Addendum 01 for RFB941100-01

Project Name: DAS 6200 Park ALJ - Workman's Comp Renovation
DAS RFB #: 941100-01
DAS Project #: 9411.00
Date: 9/16/2024

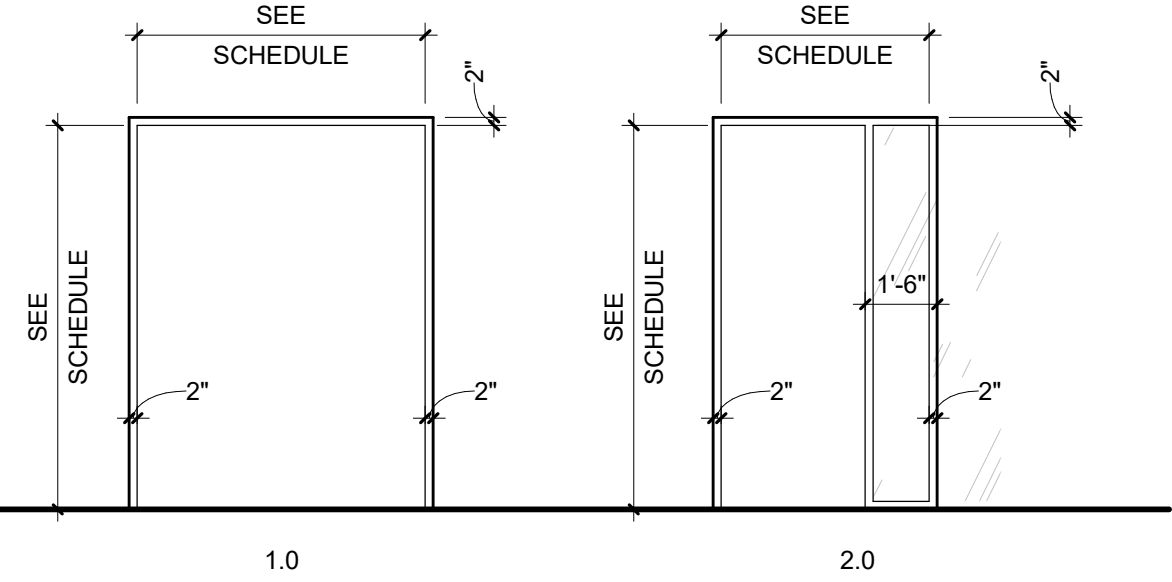
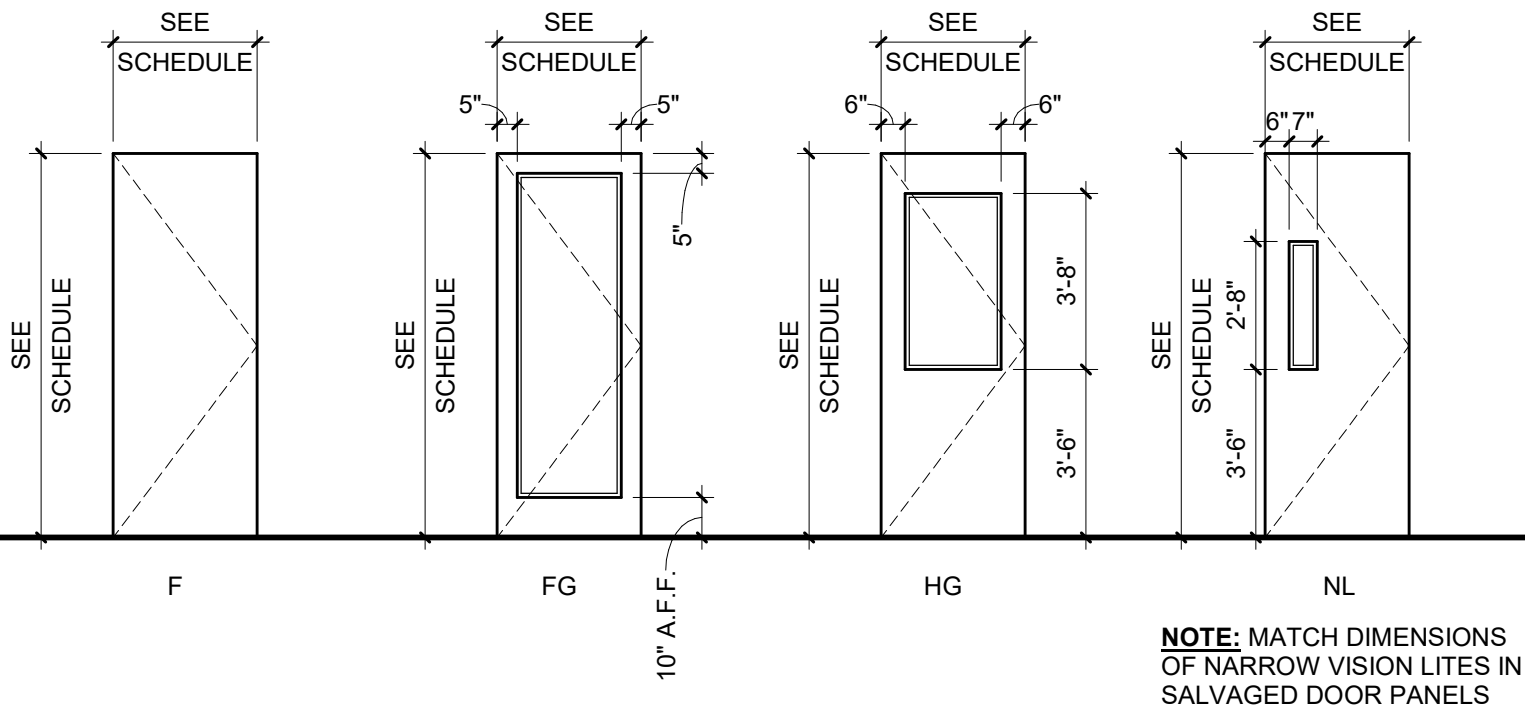
1. Sheet A001 – DOOR AND FINISH INFORMATION
 - a. Update INTERIOR FINISH SPECIFICATIONS as noted.
 - b. Revise ROOM FINISH SCHEDULE as noted.
 - c. Revise Door B125 in the DOOR SCHEDULE as noted.
